**Report of the Committee on
Fixed Guideway Transit Systems**

This Report was prepared by the Technical Committee on Fixed Guideway Transit Systems and proposes for adoption amendments to NFPA 130-1993, **Standard for Fixed Guideway Transit Systems**. NFPA 130-1993 is published in Volume 5 of the 1994 National Fire Codes and in separate pamphlet form.

"BUTTERFLY DOOR"
PLAN & ELEVATION "STCUM"
MONTREAL, CANADA
MAY, 1994

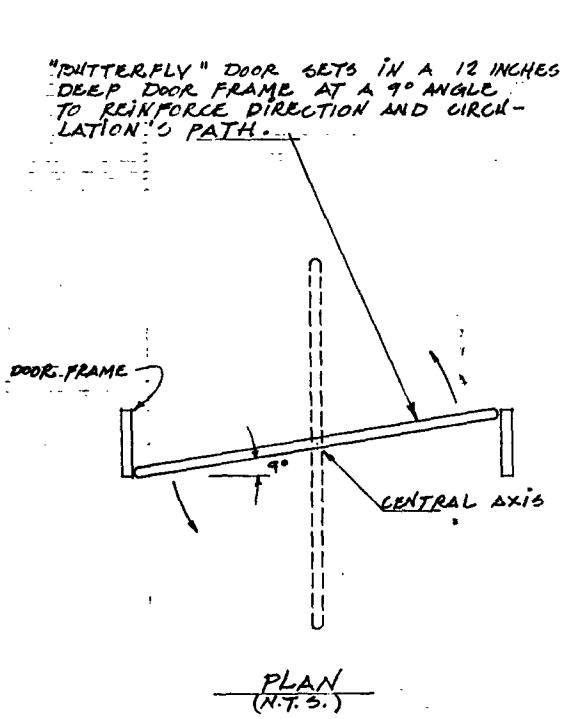
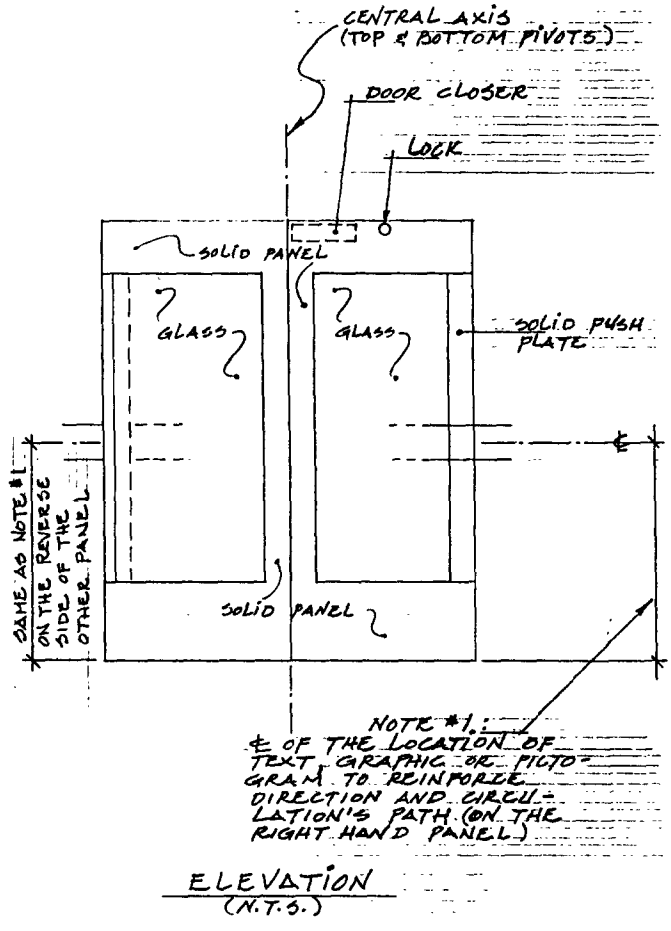
Butterfly Door. A double-panel swinging door with 2 panels joined on a common axes and positioned on an angle in the door opening such that the adverse reactions and train piston pressures are negated and safe, easy patron movement is achieved.

SUBSTANTIATION: The standard does not include this new door concept. This definition is also required for consistency with inclusion of references at the "butterfly" door in subsequent sections of the standard.

AARON: There isn't a need to provide a definition for an element that has not been accepted by NFPA 101, *Life Safety Code*.

GOURLEY: The use of butterfly doors has not been approved by the 101 Life Safety Committee. While the transit environment does warrant unique methods of calculating exit capacity, times, etc., the transit environment does not warrant unique exit doors. While the problems that the proposer's agency is having with standard doors, due to the piston effect of the trains, can be appreciated, other agencies have addressed this effect with engineering solutions that do not require the use of butterfly doors. The committee should not provide code relief for what apparently is a problem unique to the proposer's agency.

HARGROVE: I believe that these doors are potentially dangerous for use as emergency exits.

They have not been tested, certified or accepted by any credible testing agency. Until this has been done they should be treated like a revolving door for purposes of calculating exit widths and locations.

NEW: There isn't a need to provide a definition for an element that has not been accepted by NFPA 101, *Life Safety Code*.

Butterfly Door.* A single two-door panel that pivots vertically on a central axis. When closed, the door is set at an angle in a deep frame thus clearly indicating - the exit direction.

Also, add an asterisk following this title in definitions to indicate explanatory material on this subject in Appendix A. Add the following figure and text to Appendix A:

A-1-5 Butterfly Door. The butterfly door was developed to remedy the problems caused by significant variations in air pressure encountered in ventilation scenarios. The purpose of the vertical axis is to equalize air pressure on both sides of the door, thus eliminating resistance.

Add Figure A-1-5.

COMMITTEE STATEMENT: The Committee accepted other proposals to include the concept of butterfly doors in Chapter 2 in 2-5.3.7 and has therefore included a new definition as recommended by the submitter. The committee felt that language included in 130-34 (Log #4) by the same submitter was a better definition and used the last two sentences of that recommendation for the definition shown above. See also Committee Action on 130-17 (Log #2).
